# Service Bulletin

Bulletin No. 2005-64  
CMD 2005-04

## OIL PRESSURE SENDER / COOLANT RESERVOIR (EXPANSION TANK) / HEAT EXCHANGER MODIFICATIONS

Models Affected	Serial Number Or Year
2.8 ES 170 / 2.8 EI	88005200 to 88005228
2.8 ES 200 / 2.8 EI	88010026 to 88010550

### Oil Pressure Senders

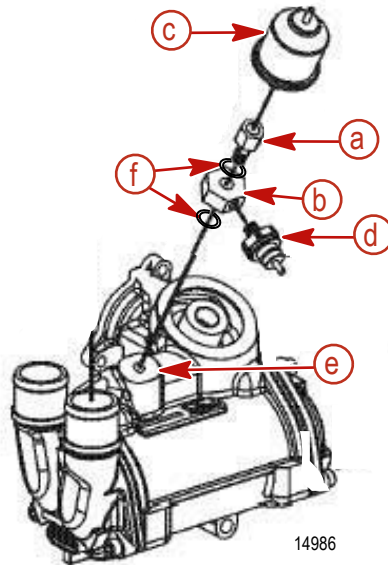
On engines in the above noted serial number range, modifications to the oil pressure sender, coolant reservoir (expansion tank) and heat exchanger are advised. These modifications are intended to reduce the possibility of a minor oil leak, improve cooling component mounting durability and should be carried out during routine or scheduled servicing of the product.

1. Remove and retain the oil pressure sender.
2. Remove and retain the oil pressure switch.
3. Remove and discard the oil pressure sender adapter.
4. Remove and discard the oil pressure switch base and the 2 sealing washers.
5. Install the oil pressure switch base, oil pressure sender adapter and sealing washers into the oil cooler housing.

- Using a suitable wrench, position the threaded hole on the oil pressure switch base to port. Torque the adapter.

Description	Nm	lb. in.	lb. ft.
Oil pressure sender adapter	30		22

- Install the oil pressure switch into the oil pressure switch base. Torque the oil pressure switch.

Description	Nm	lb. in.	lb. ft.
Oil pressure switch	10.8	95

- Install the oil pressure sender into the oil pressure sender adapter. Torque the oil pressure sender.

Description	Nm	lb. in.	lb. ft.
Oil pressure sender	10.8	95

### Coolant Reservoir (Expansion Tank)

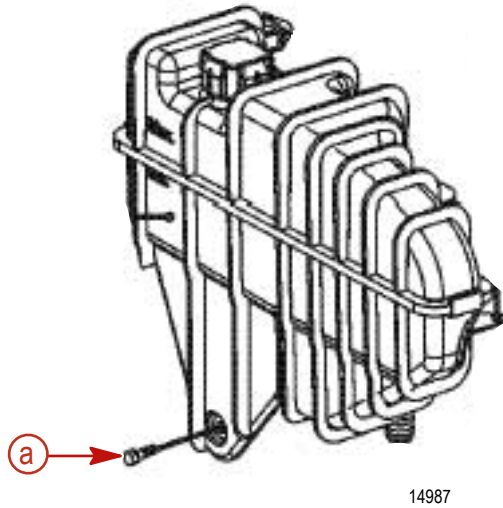
1. Remove and discard the M6 x 30 mm lower mounting screw.
2. Using a M6 x 1.0 bottoming tap, increase the length of the threads in the thermostat housing lower mounting port for the coolant reservoir (expansion tank) by 5 mm.
3. Install the new M6 x 35 mm lower mounting screw into the lower mounting port of the coolant reservoir (expansion tank). Torque the screw.

Description	Nm	lb. in.	lb. ft.
Lower mounting screw M6 x 35	10.8	95

### Heat Exchanger

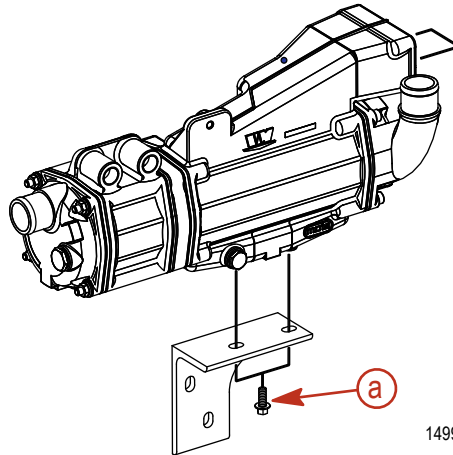
1. Remove and discard the existing M8 x 15 mm heat exchanger lower bracket mounting screws.

2. Install the new M8 x 20 mm heat exchanger lower bracket mounting screws. Torque the screws.

Description	Nm	lb. in.	lb. ft.
Heat exchanger lower bracket mounting screwsM8 x 20	19.6	173
